## PLANNING & ZONING COMMISSION

TO: Michelle Eddy, CMC/CPM - Town Manager/Clerk  
FROM: Kyle Parag, Plan Reviewer - CAA  
DATE: March 16, 2023  
RE: Planning/Zoning/Architectural Guidelines review –  
0033 Golden Crown Ln

TO: Michelle Eddy, CMC/CPM - Town Manager/Clerk  
 FROM: Kyle Parag, Plan Reviewer - CAA  
 DATE: March 29th, 2023  
 RE: Planning/Zoning/Architectural Guidelines review –  
 0066 Conifer Dr

**TO: Michelle Eddy, CMC/CPM - Town Manager/Clerk**  
**FROM: Thomas Marshall, Plan Reviewer - CAA**  
**DATE: May 31, 2022**  
**RE: Planning/Zoning/Architectural Guidelines review –  
0066 Conifer Drive**

**Revised**

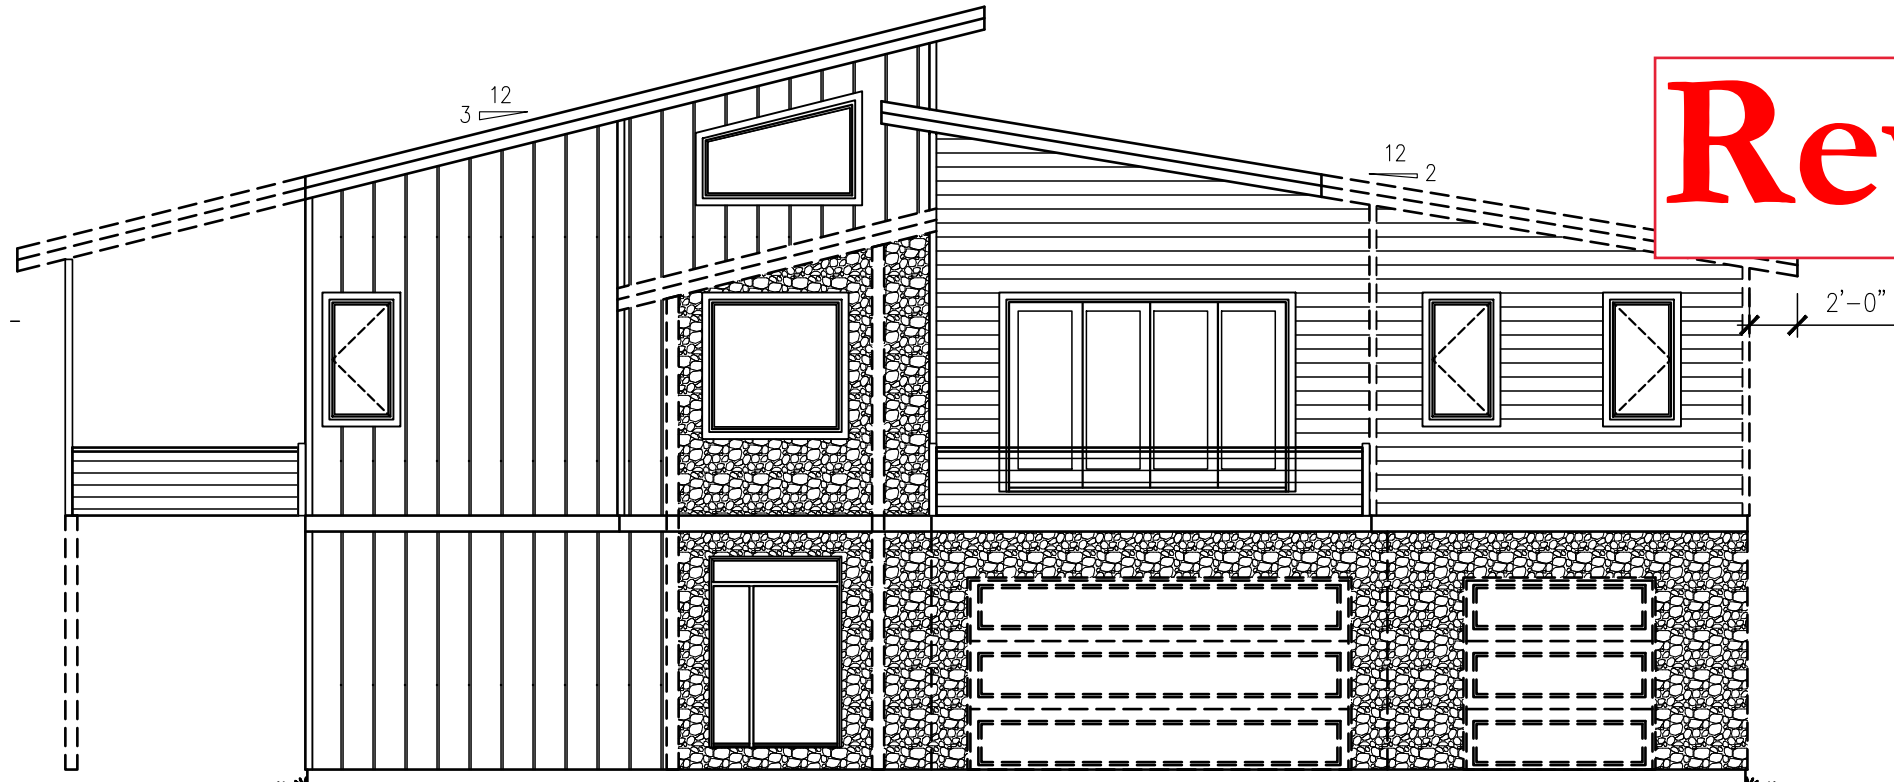
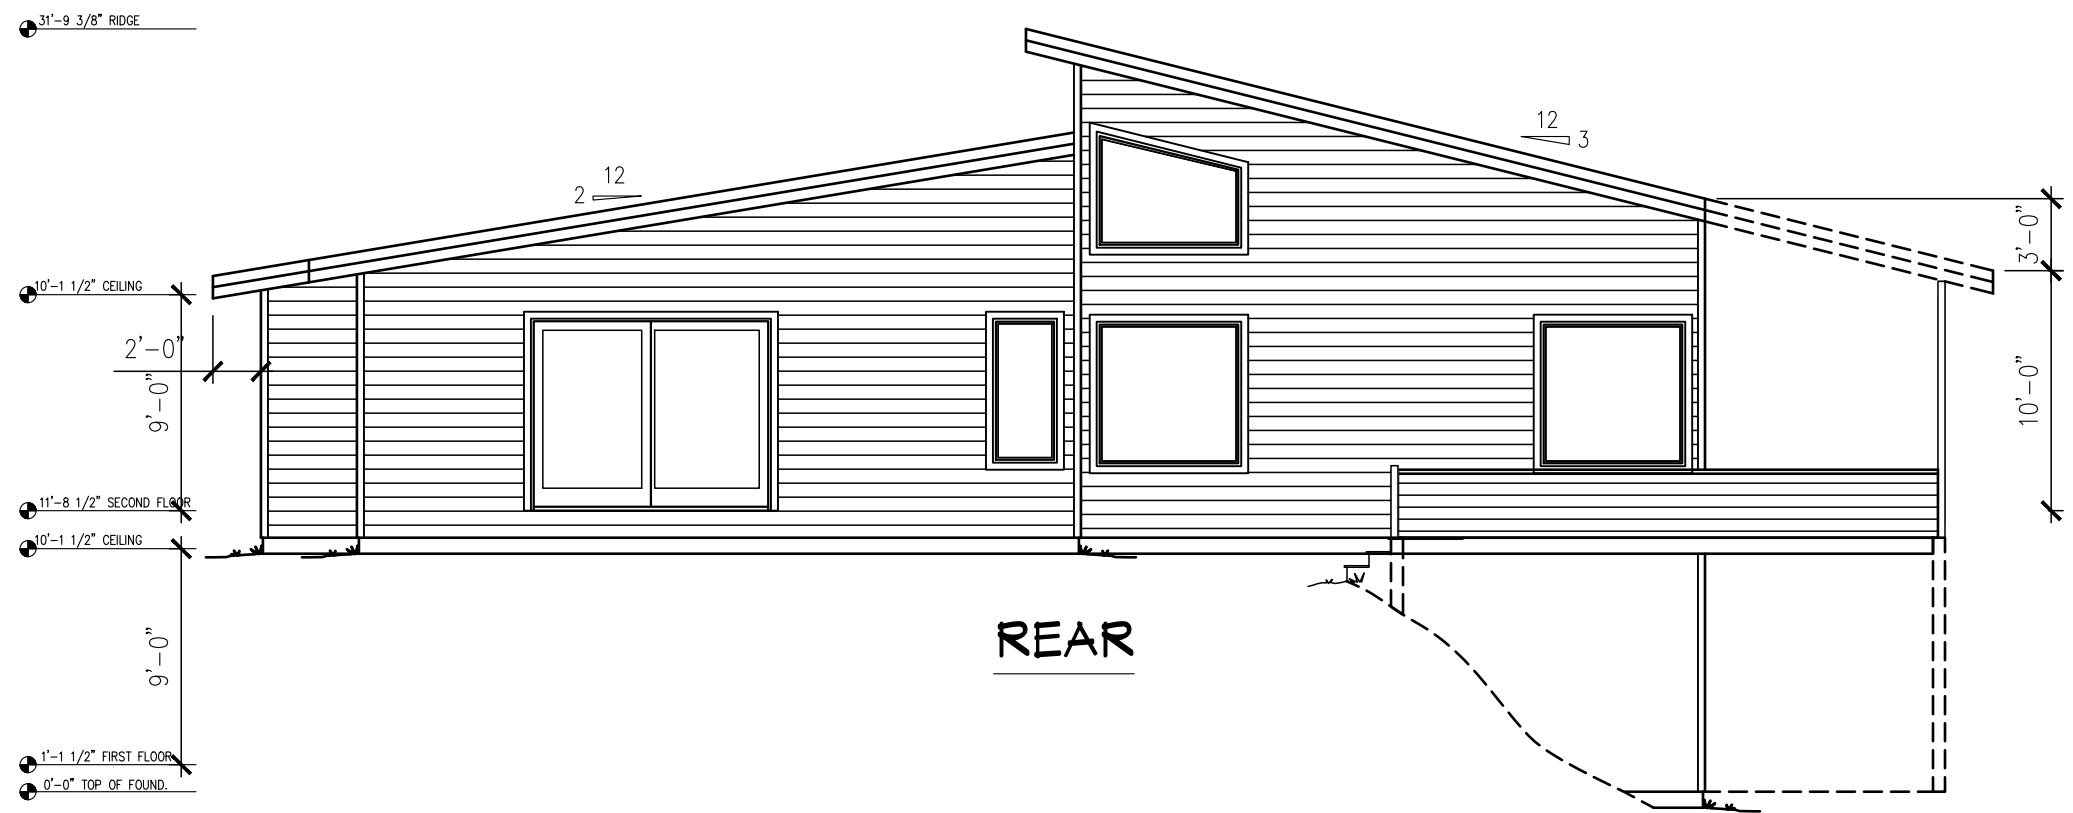
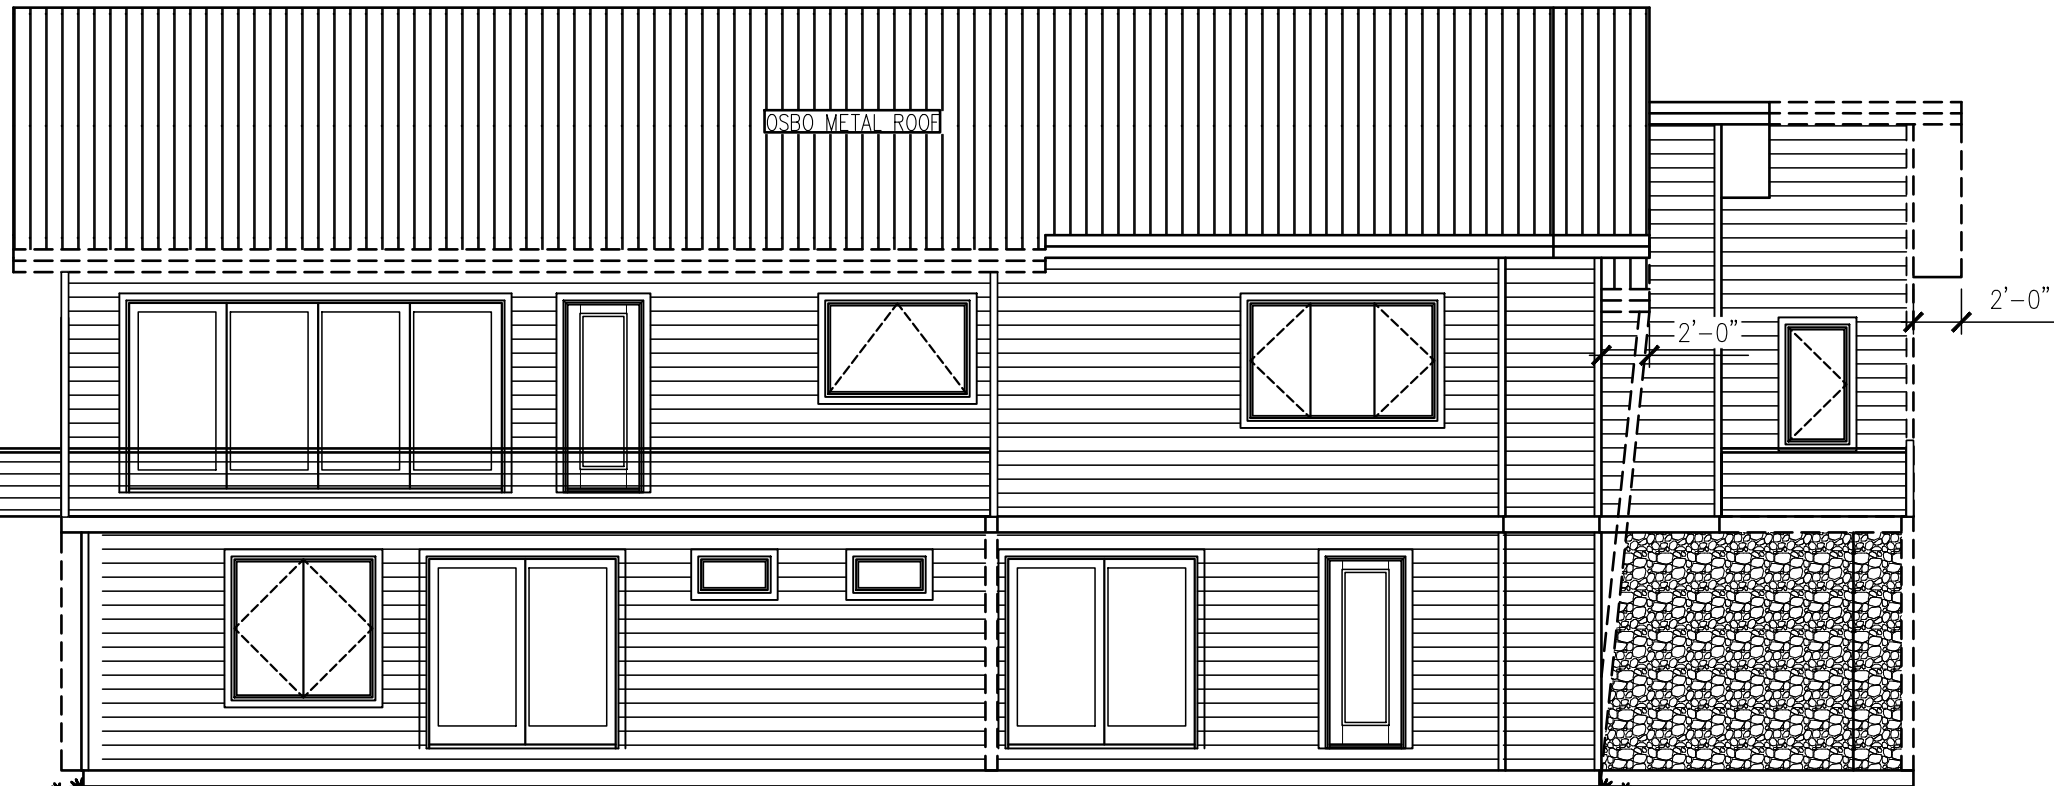
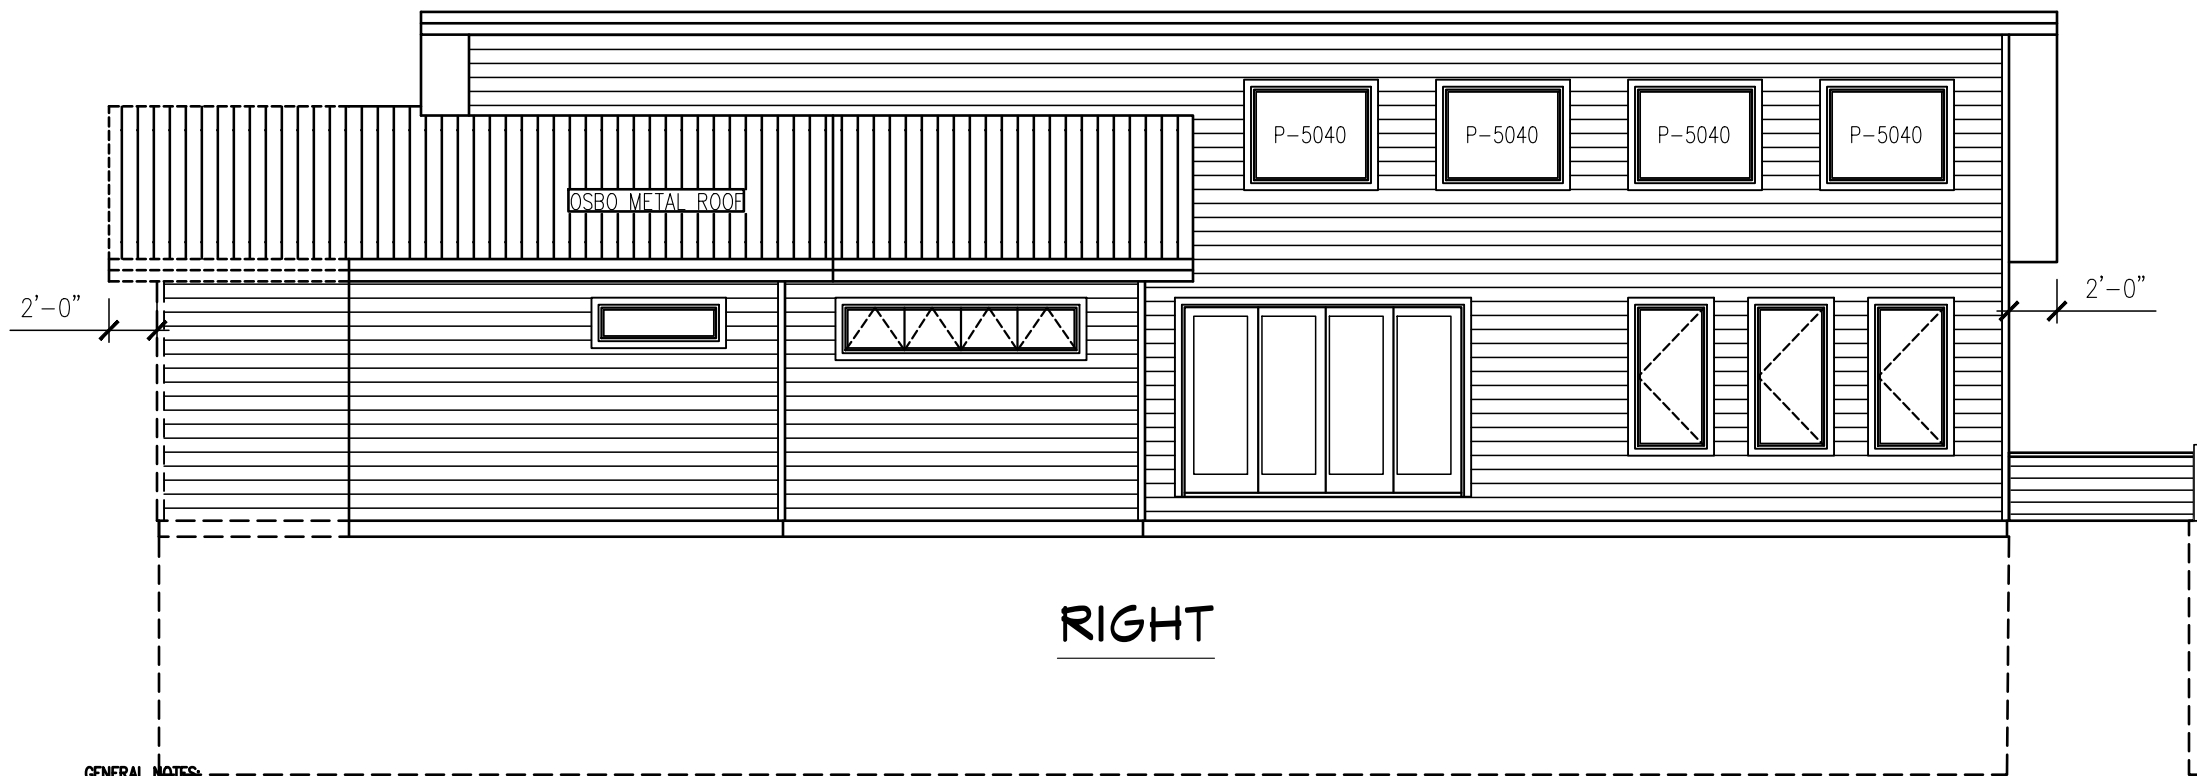
<p>VII. E. Roofs</p>	<p><b>Double shed roof with a slope of 2:12 and 3:12 is proposed. Primary roofs should be 4:12 or steeper. Guidelines allow lower primary roofs to be considered.</b>  Material is proposed as a charcoal metal roof.  Snow shedding is not a concern.</p> <p><b><u>HOMEOWNER RESPONSE:</u></b>  Previously submitted plan with same roof slope was approved at Town of Blue River for the same address.</p>
--------------------------	--

<p>VII. J. Chimneys and Roof Vents</p>	<p><b>An indoor fireplace is proposed. Neither the chimney nor a roof vent is identified. Please indicate if this fireplace is vented out the side of the home, or through the roof. If through the roof, please provide enclosure material or indicate the painting of the vent extension to match the roof material.</b></p> <p><b><u>HOMEOWNER RESPONSE:</u></b>  Fireplace will be vented through roof and capped with a D Type Roof Vent in black as shown below</p> 
--	---

**PLOT AND  
EC PLAN**

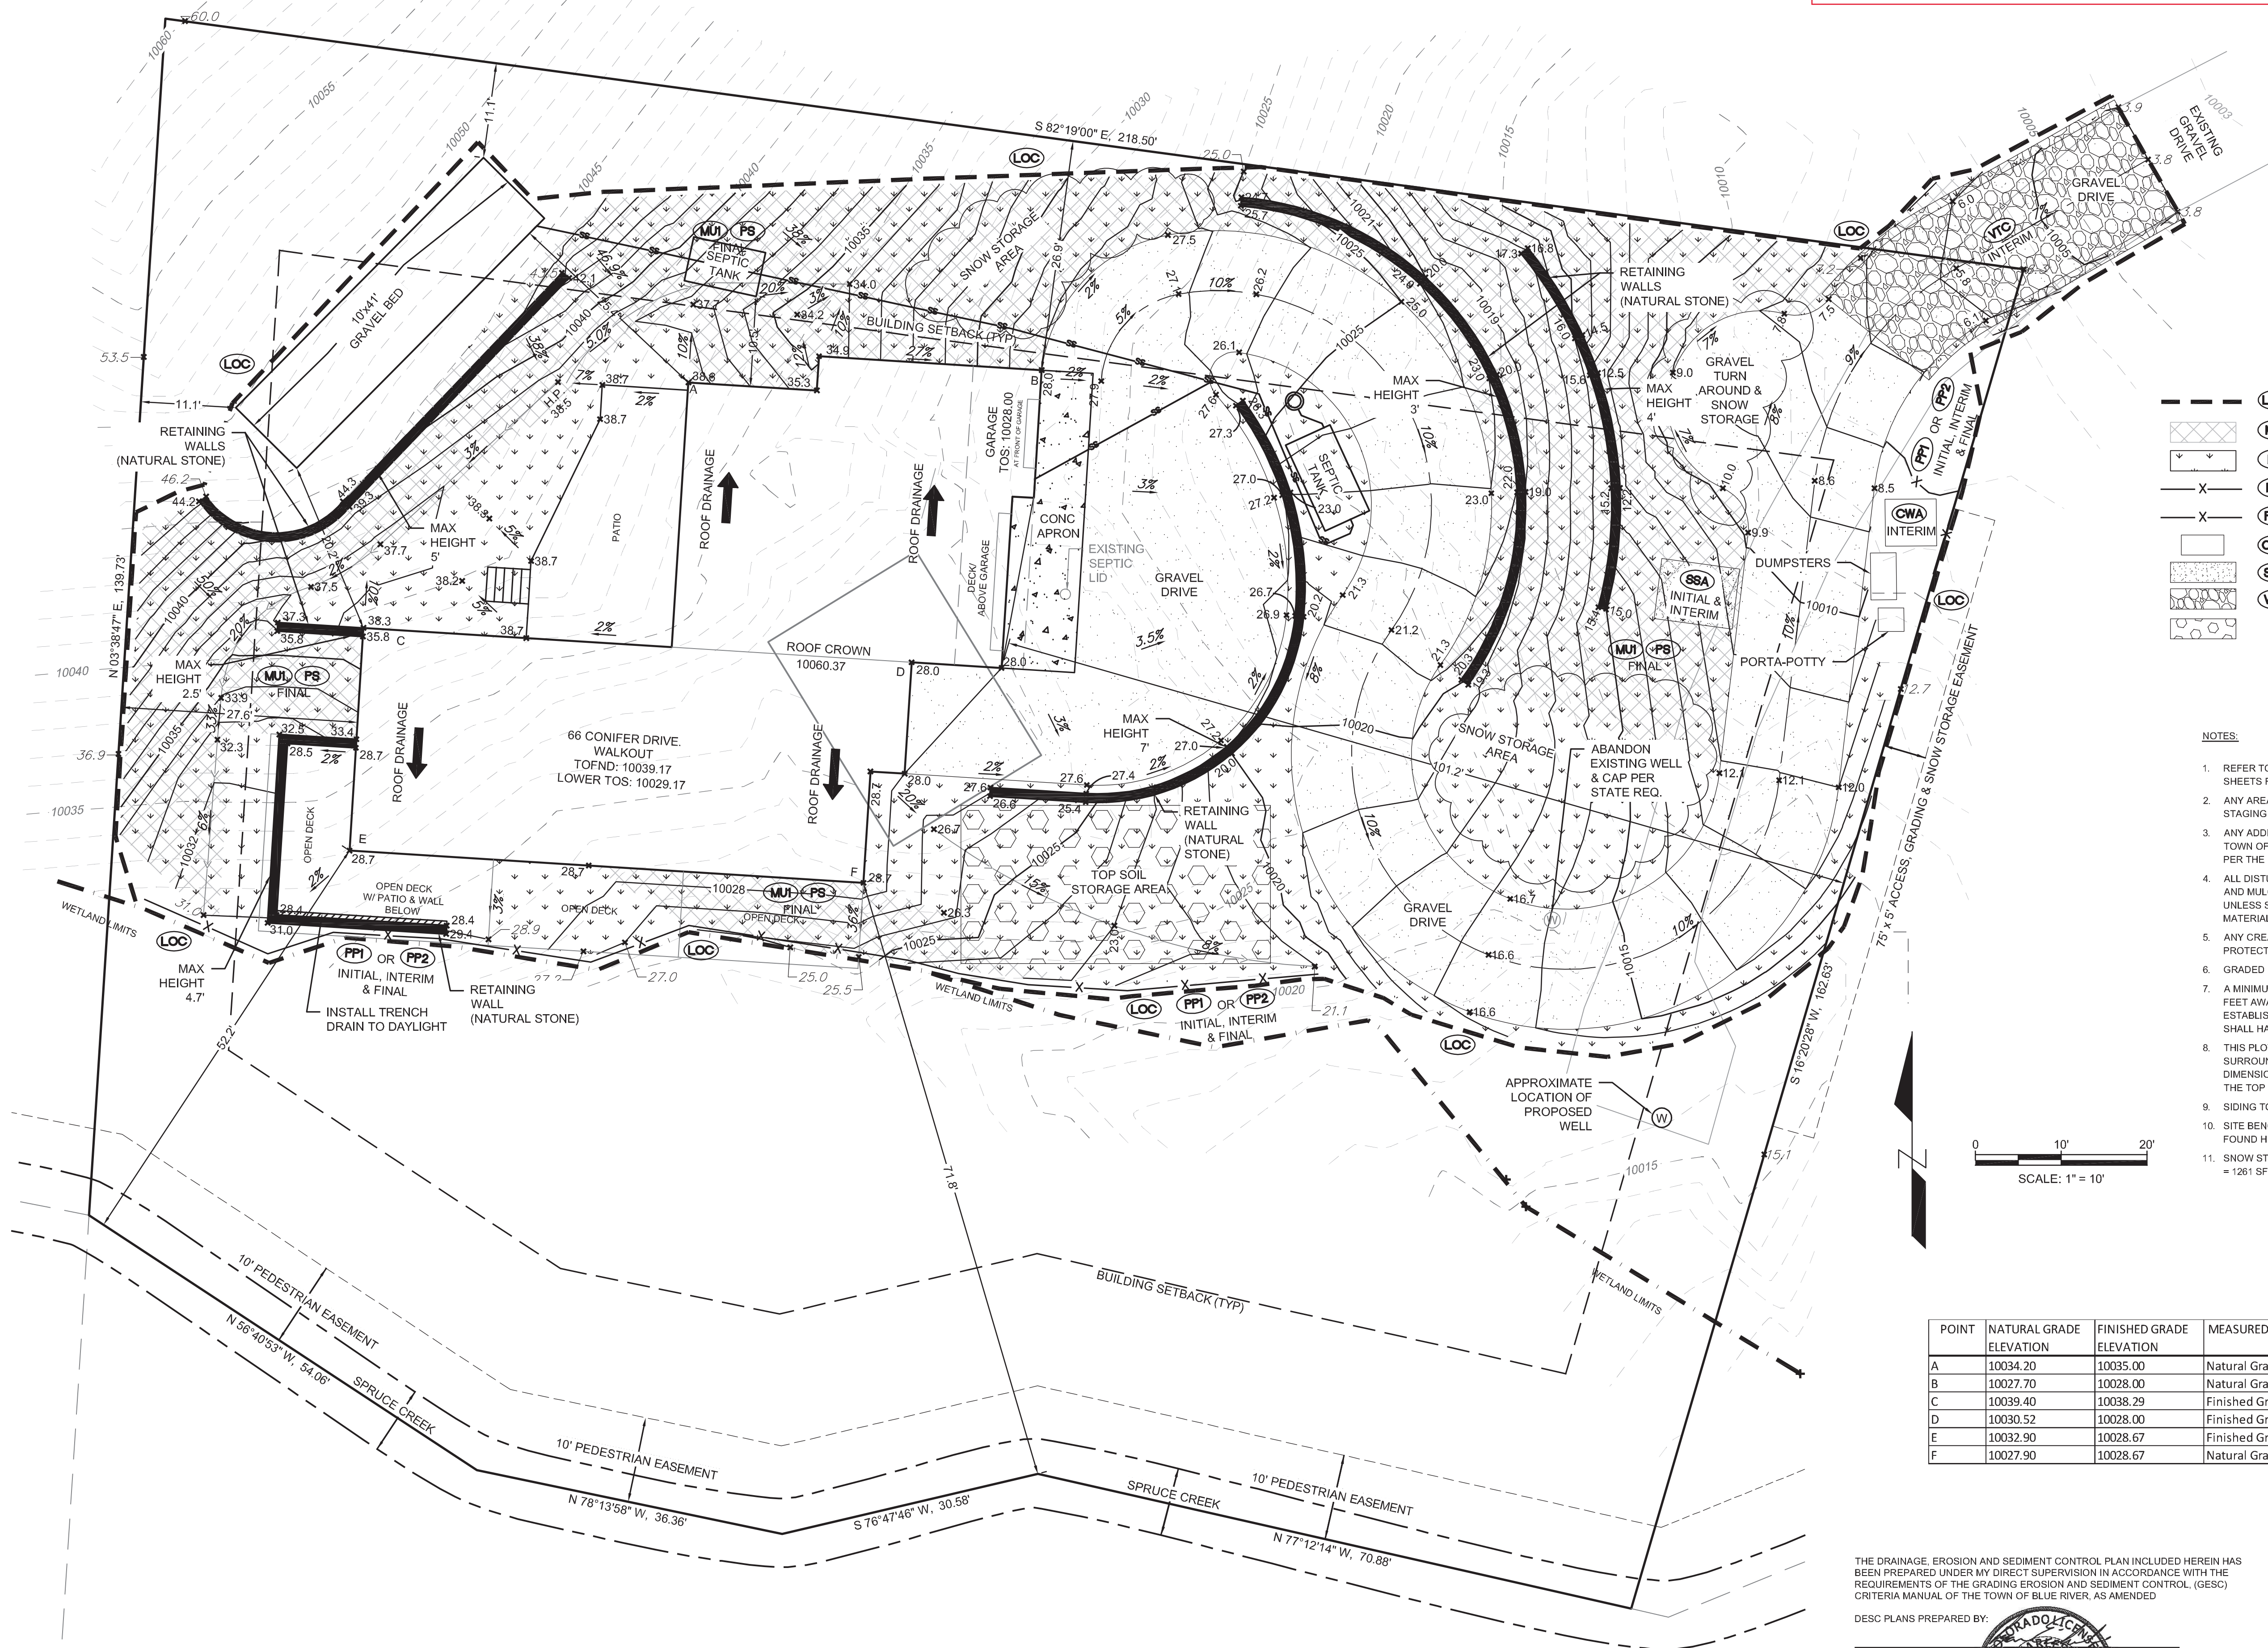
<p>VIII. A. Retaining Walls, Landscape Walls, Fences, and Screening</p>	<p>Large retaining walls are proposed along driveway and at rear of home near septic. <b>Materials and maximum height could not be located.</b></p> <p><b><u>HOMEOWNER RESPONSE:</u></b> See updated site plan for details.</p>
---	---

<p>IX. B. Submittal Requirements</p>	<p><b>The construction management plan is not included in the submittal.</b> <b>Detailed landscape plan is not included.</b></p> <p><b><u>HOMEOWNER RESPONSE:</u></b> See updated site plan for details on construction management plan. Reference email communication dated Wednesday, March 8<sup>th</sup> subject "Confirming on Landscape Plan". It was confirmed that details outlined on the site plan would suffice for the landscape plan.</p>
--	--
